# UNITED STATES PATENT AND TRADEMARK OFFICE

APPLICATION NO.	FILING DATE	FIRST NAMED INVENTOR	ATTORNEY DOCKET NO.	CONFIRMATION NO.
09/986,117	11/07/2001	Paer von Malmborg	030481-0181	4675

# Office Action Summary

## DETAILED ACTION

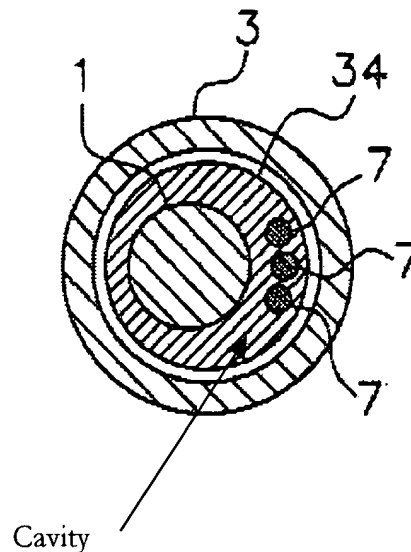
7. Applicant's arguments filed 8/21/03 have been fully considered but they are not persuasive. In regards to Akerfeldt et al., applicant asserts that Akerfeldt et al. does not teach a cavity being proximate to the core wire. The examiner has included a figure to better illustrate the cavity proximate the core wire. The cavity is formed as a result of the shape of the core wire. The core having the size and shape as shown creates a cavity by not filling the entire connector. It has been held that the recitation that an element is "adapted to" perform a function is not a positive limitation but only requires the ability to so perform. It does not constitute a limitation in any patentable sense. *In re Hutchison*, 69 USPQ 138. In the present case, the cavity as disclosed by Akerfeldt et al. would remain intact as long as substantial bending does not occur. In regards to Akerfeldt et al. in view of Abrahamson et al., applicant asserts that Abrahamson et al. does not disclose a "core wire" having a D-shaped cross-section; that the D-shaped portion is merely a hole in a catheter. The examiner agrees. However the teaching that Abrahamson et al. provides is of a D-shaped core that is used to provide a cavity through which wires can extend. It would have been obvious, in view of Abrahamson et al. to modify the core wire as disclosed by Akerfeldt et al. to include such a shape as taught by Abrahamson et al. in order to form a protective recess.
